AUBURN HILLS 2ND ADDITION

Re: S/D 96-37 - One Step Preliminary-Final Plat of the AUBURN HILLS 2nd ADDITION

STAFF REPORT

CASE NUMBER: S/D 96-37 AUBURN HILLS 2ND ADDITION

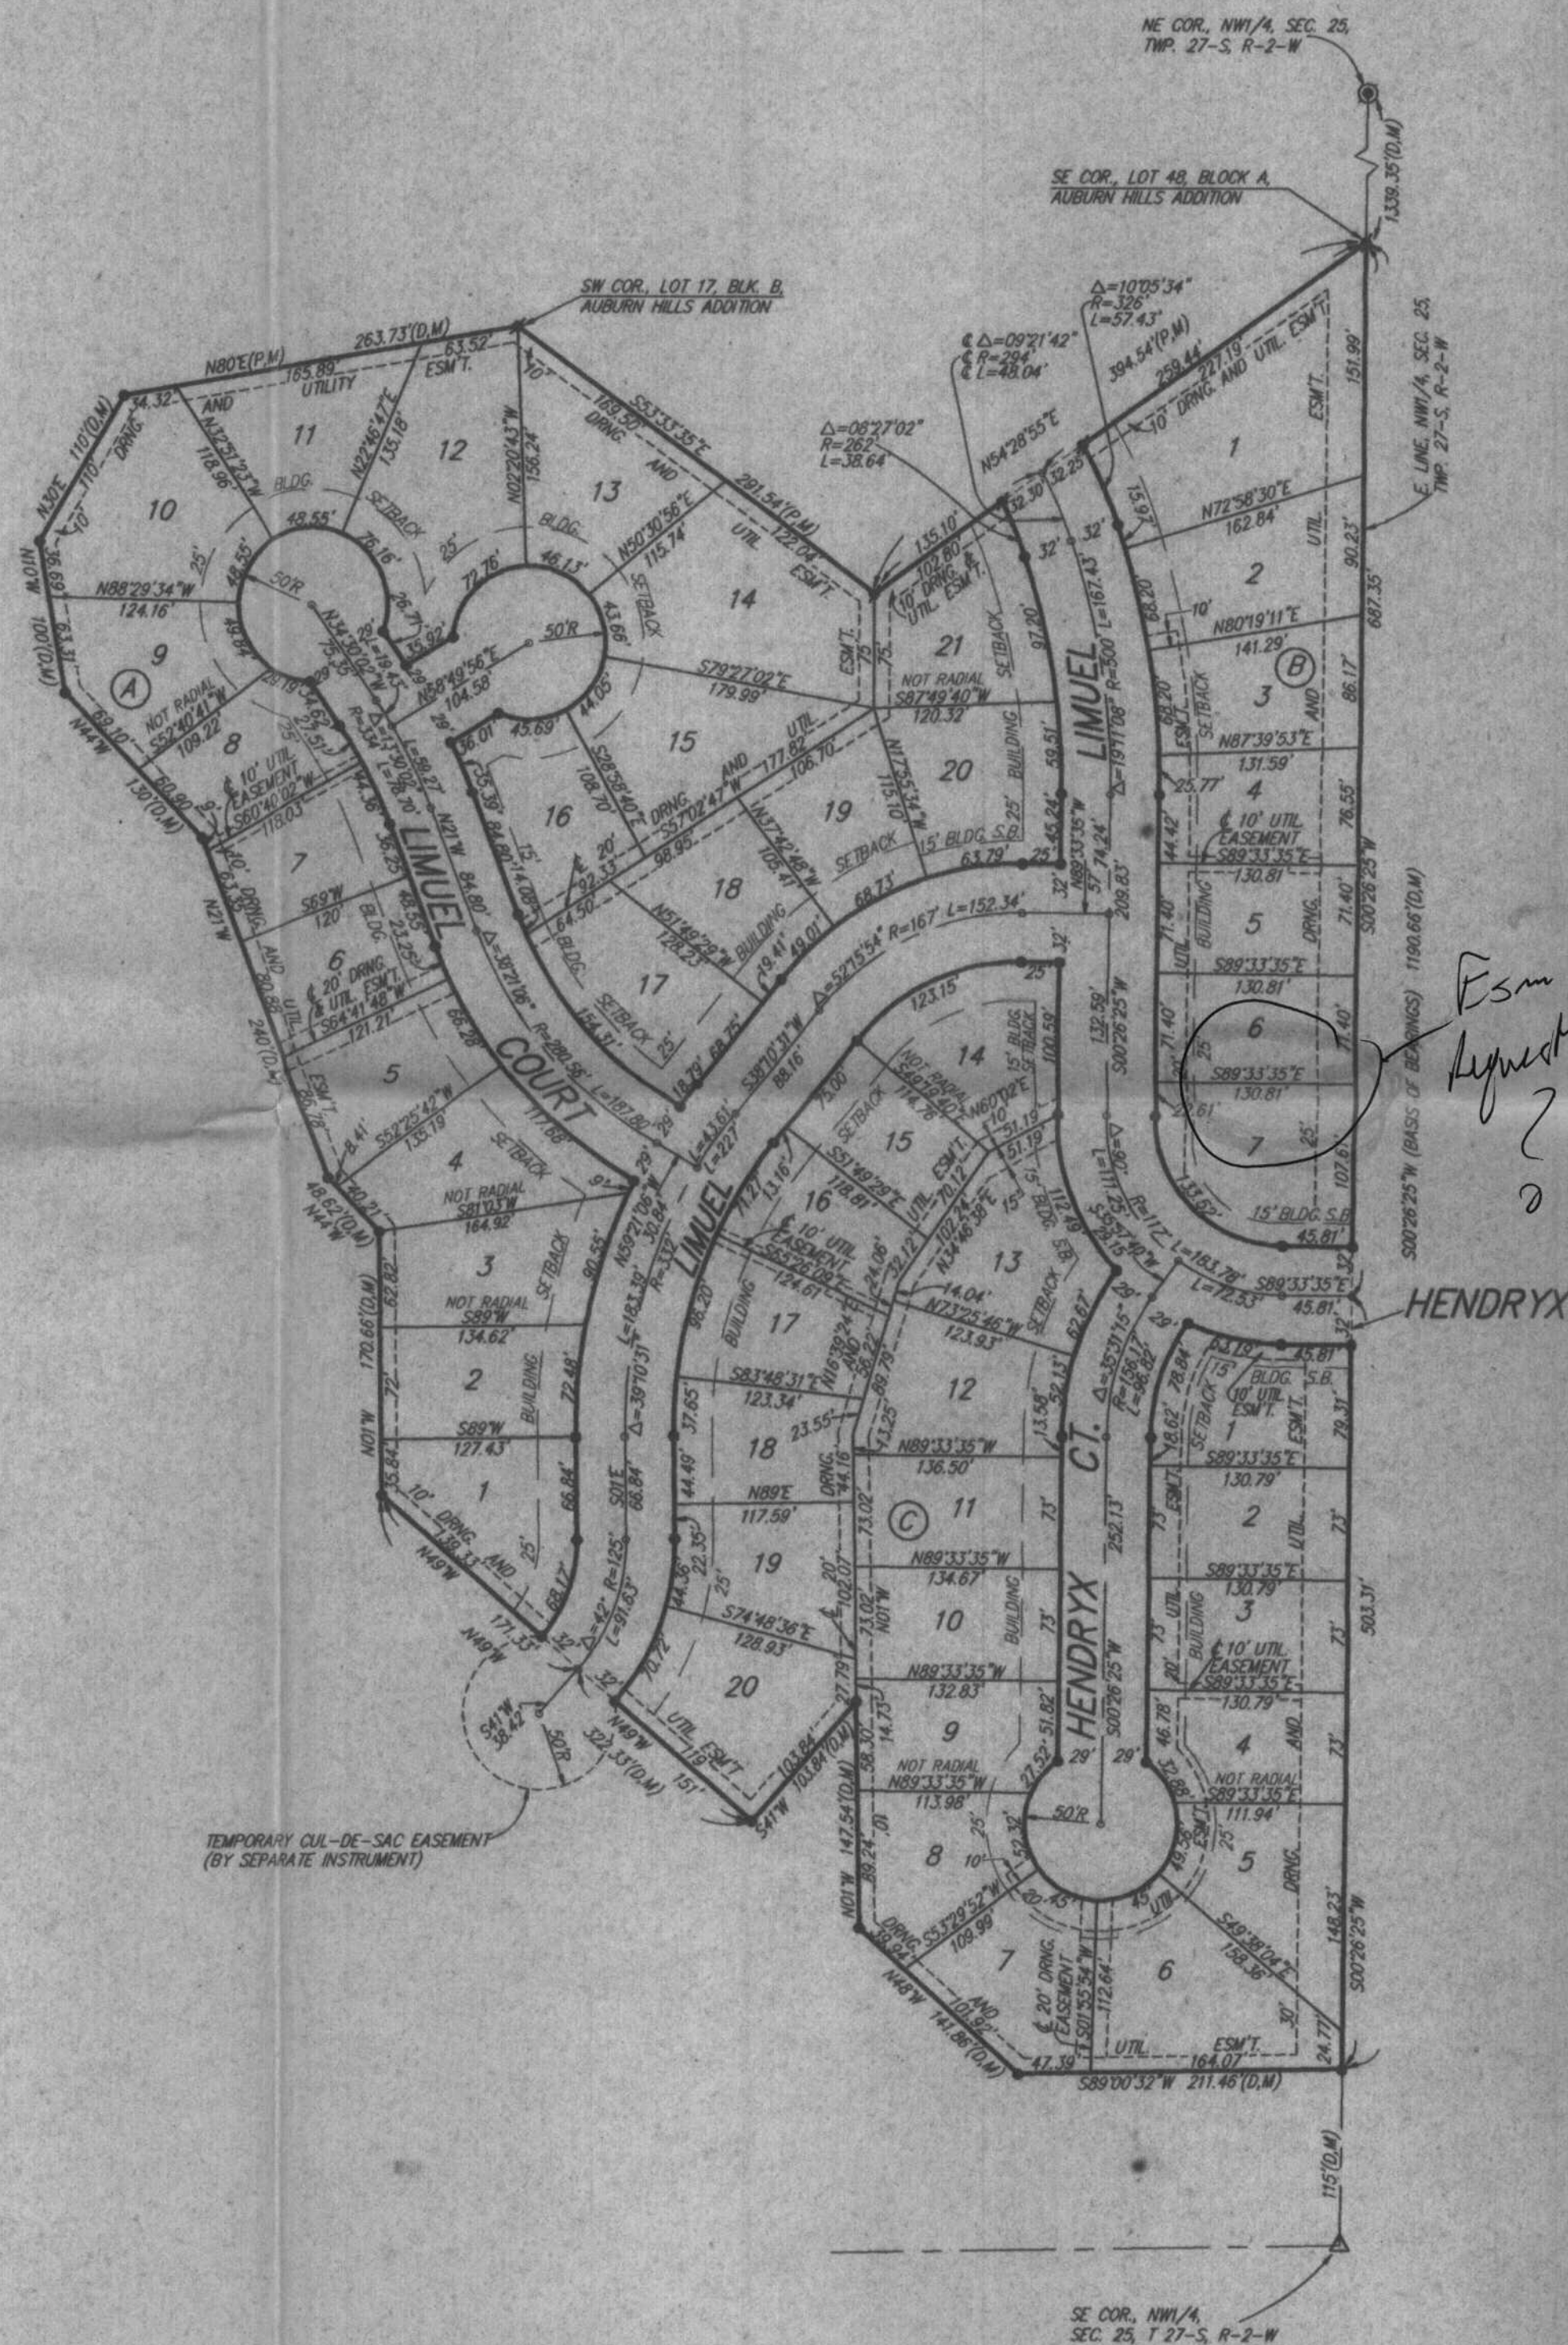
- F. The applicant shall guarantee the paving of the proposed interior streets. This guarantee shall also provide for sidewalks along one side of Limuel and Hendryx (so as to connect to the sidewalk system required in the Maple Valley Addition).

- I. The off-site temporary cul-de-sac needs to be created by separate instrument. Such instrument should be submitted to Planning for processing with the final plat tracing.

- J. The applicant shall submit a covenant which provides for four (4) off-street parking spaces per dwelling unit on each lot which abuts a 58-foot street. The covenant shall inventory the affected lots by lot and block number and shall state that the covenant runs with the land and is binding on future owners and assigns.

- K. On the final plat tracing, the City's signature block shall be amended by deleting "Deputy" from the City Clerk's signature line.
- L. If additional, off-site utility easements are required along the west line of this plat, these easements shall be granted by separate instrument and submitted to Planning for processing with the final plat tracing.

- M. On the final plat tracing, Lot 16, Block A shall be properly depicted. The plat presently shows two (2) Lot 17's at that area of the plat.
- N. The applicant shall install or guarantee the installation of all utilities and facilities which are applicable and described in Article 8 of the MAPC Subdivision Regulations. (Water service and fire hydrants required by Article 8 for fire protection shall be as per the direction and approval of the Chief of the Fire Department.)

- T. The final plat shall indicate the utility easements requested by K.G. & E. which are indicated on the enclosed "marked" copy of the plat.

U. The City Fire Department indicated that there are 90° turns on Hendryx and Limuel. The applicant should contact Central Inspection for addressing purposes.
